ISSUES & REVISIONS		DATE:
FOR PERMIT		AUGUST 9, 2023
FOR CONSTRUCTION		MARCH 25, 2024
CONSTRUCTION BULLETIN #1		MAY 15, 2024
CONSTRUCTION BULLETIN #2		NOVEMBER 15, 2024
LIGHTING SPECIFICATIONS REQUEST		FEBRUARY 13, 2025
CONSTRUCTION BULLETIN #3		FEBRUARY 20, 2025
OWNER APPROVED PLANS		FEBRUARY 28, 2025

PROJECT TITLE:	
LOPA COMPOUND DEVELOPMENT	
Lopa Farm Marilaque Highway Sitio Mayagay, Brgy. Sampaloc, Tanay Rizal

SHEET CONTENTS:	
HOUSE 5 FLOOR PLAN AND ROOF PLAN

A-200

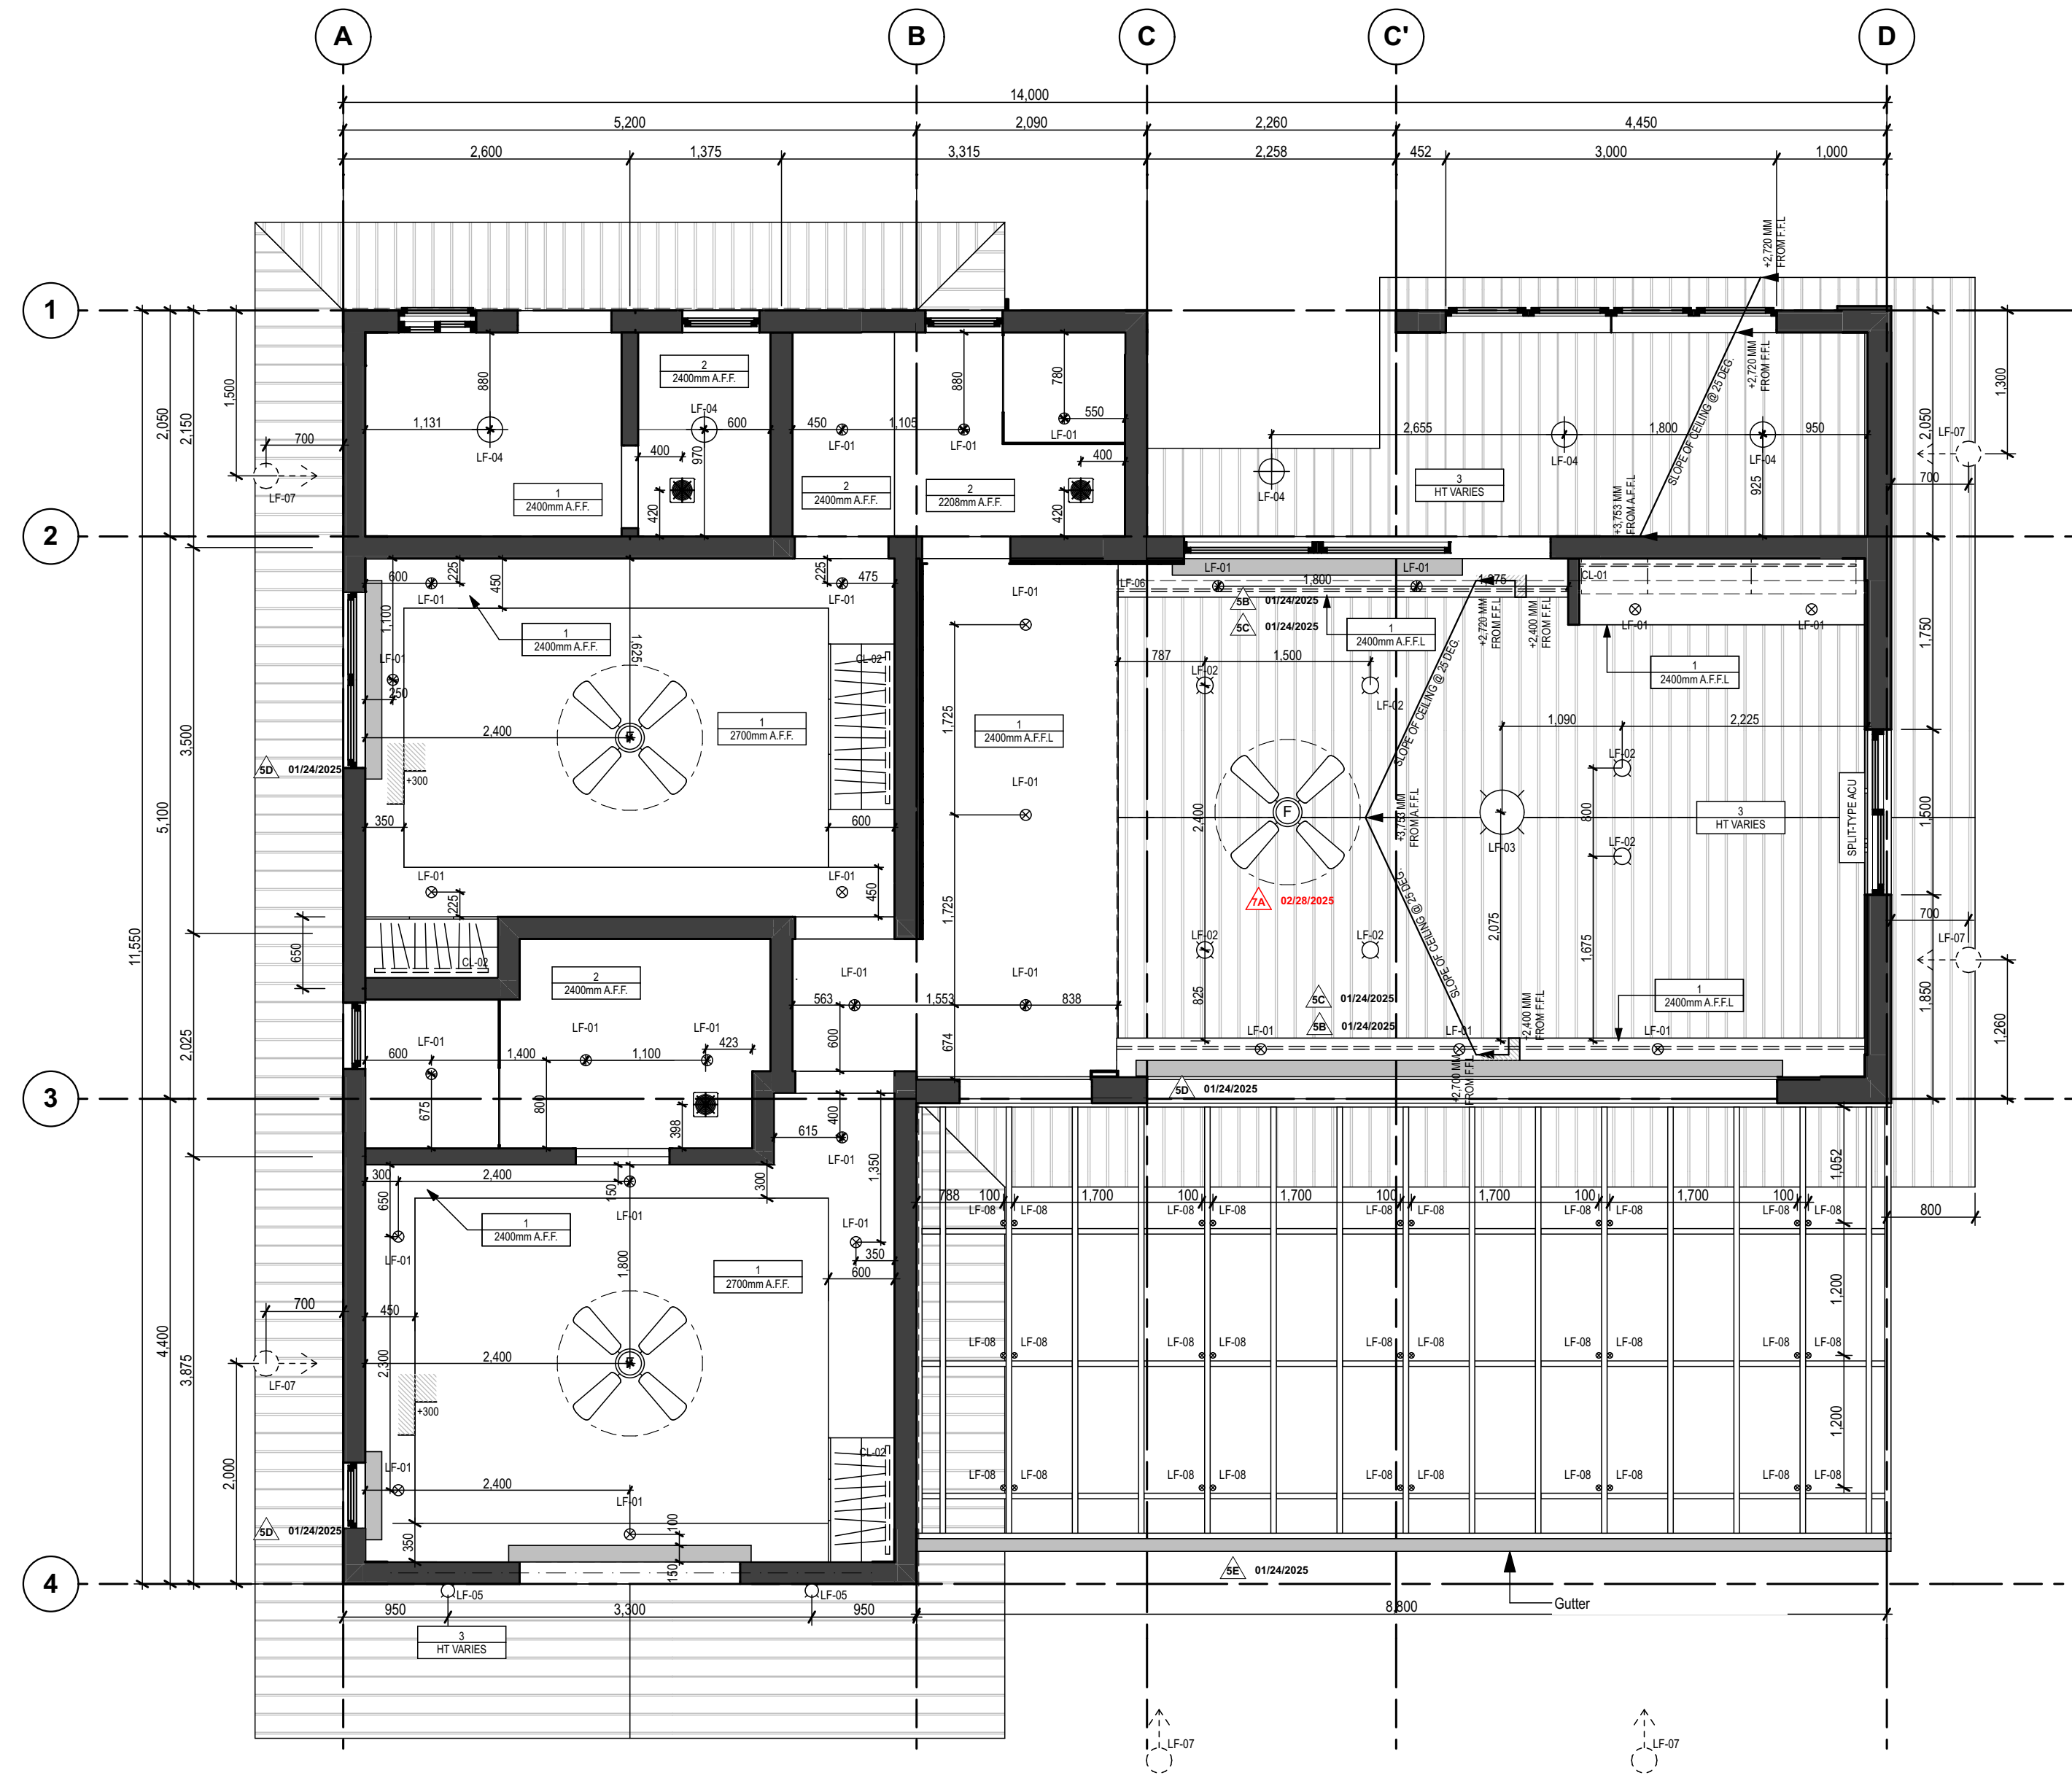
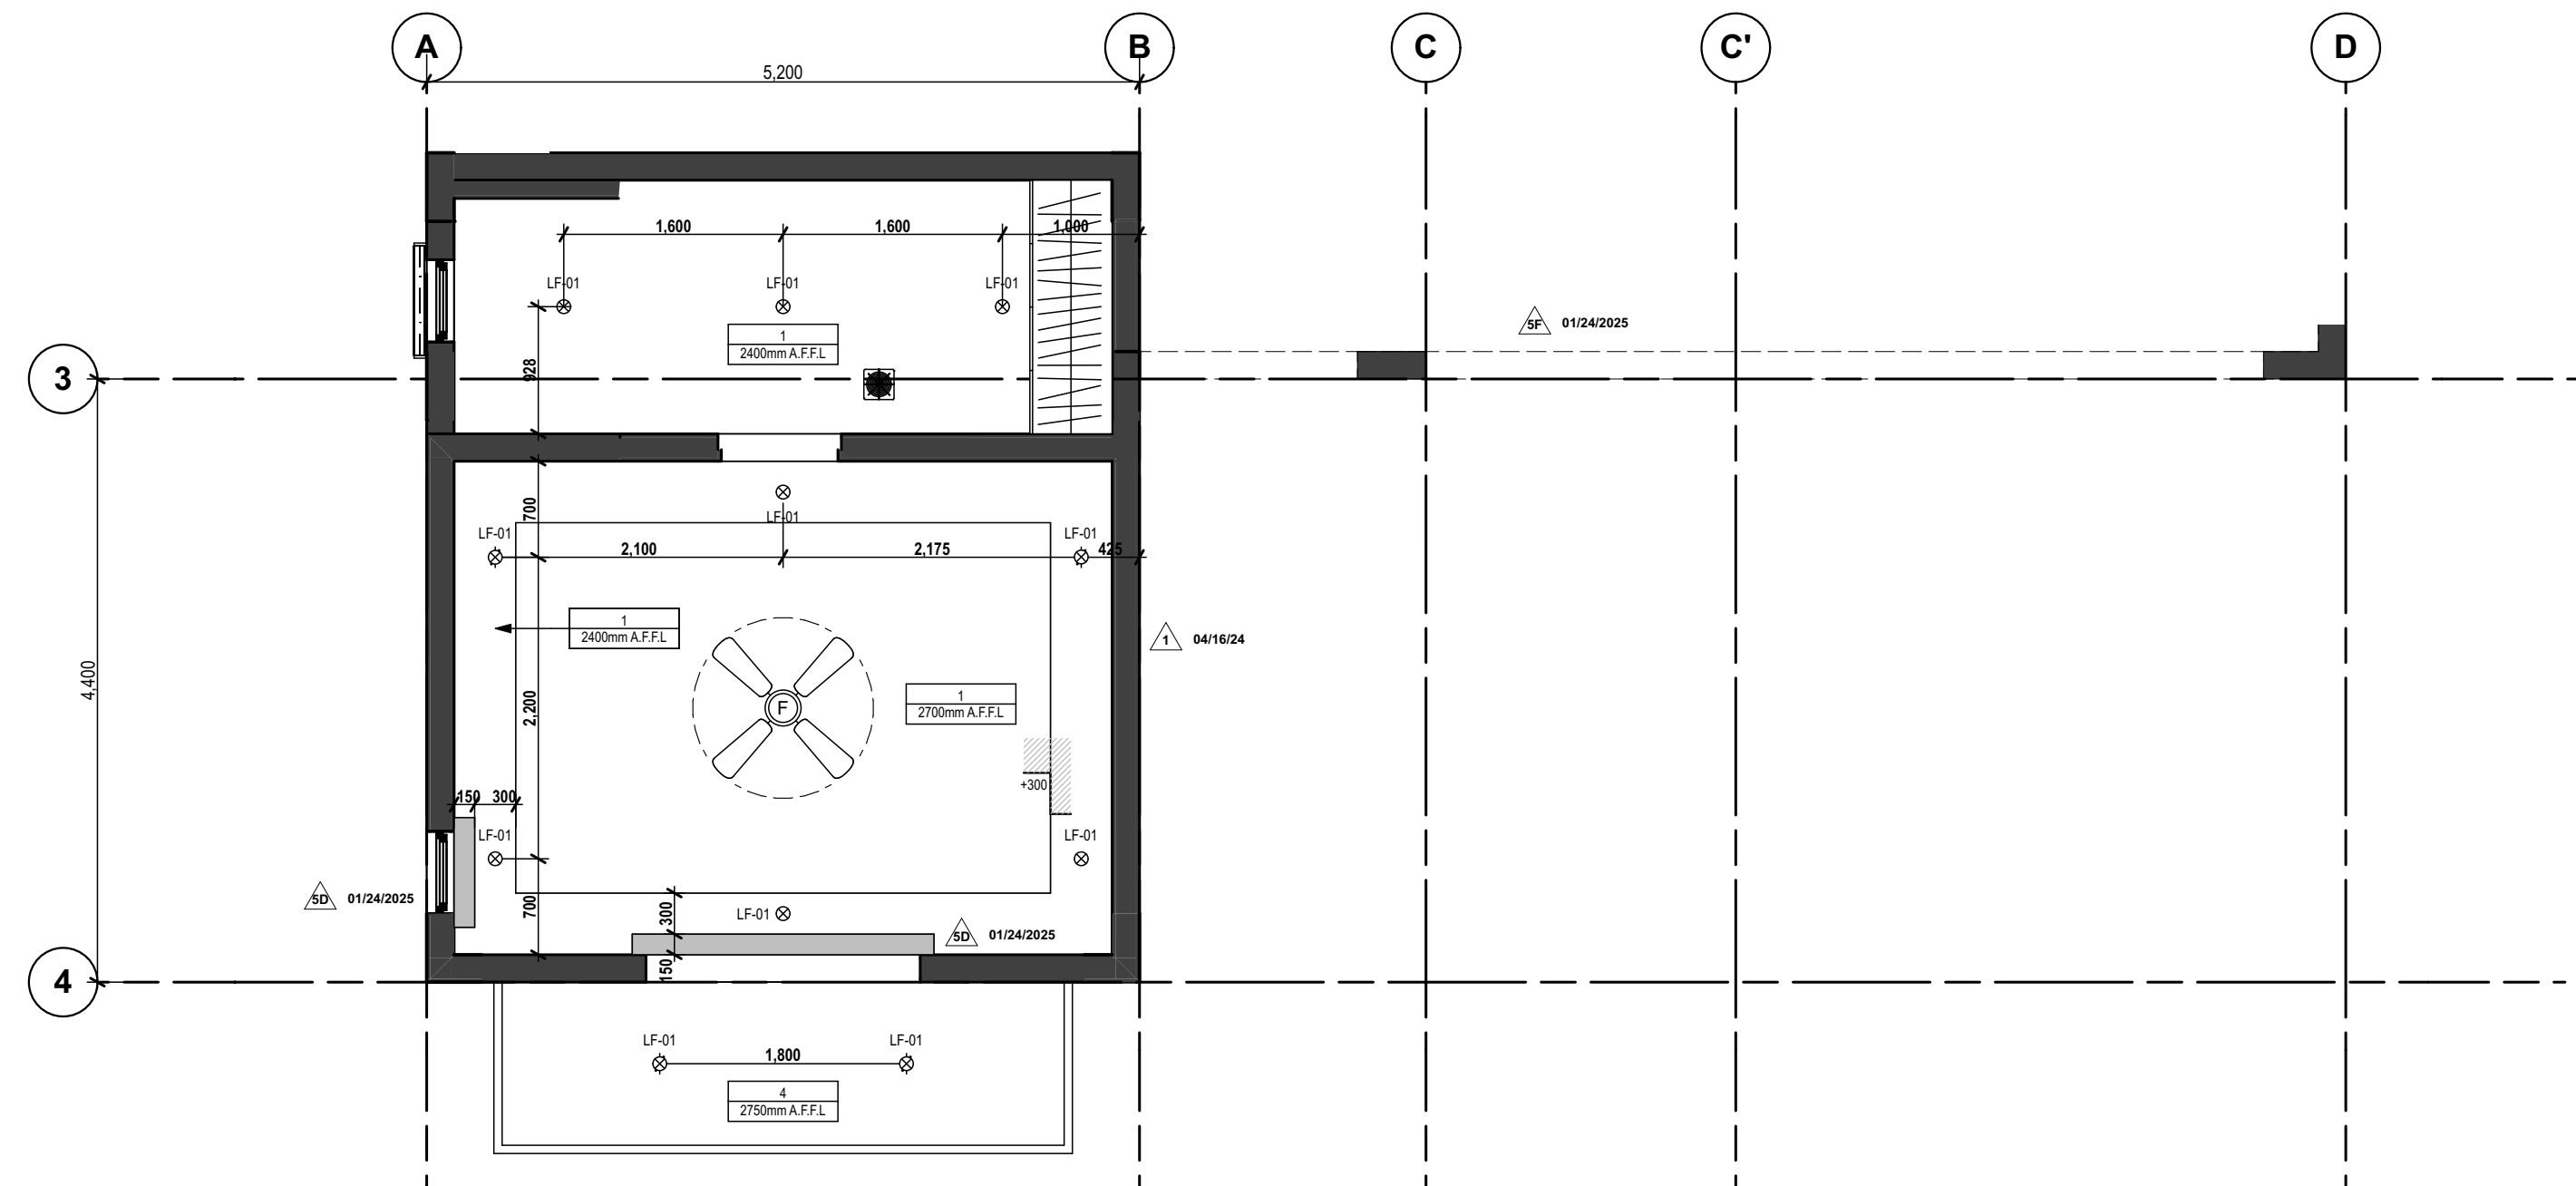
REVISION NOTES	
NOVEMBER 15, 2024	4A - REFLECTED FLOOR ELEVATION/DEPRESSION ON FLOOR FINISH PLAN
	4B - VERIFIED ELEVATIONS
JANUARY 24, 2025	5A - ADDITION OF CABINET AT BEDROOM
	5B - ADJUSTMENT OF COVE LIGHTING ELEVATION FROM 2700 TO 2400
	5C - ADDITION OF GENERAL LIGHTING
	5D - ADDITION OF CURTAIN COVE
	5E - PROVISION OF GUTTER TO THE GLASS TRELLIS
	5F - ADDITION OF RETAINING WALL, 1 METER HIGH FROM LEVEL 0.00 TO SERVE AS A STRUCTURAL PROTECTION FOR SLOPED LANDSCAPING AT FACADE.
FEBRUARY 28, 2025	7A - ADDITION OF CEILING FAN
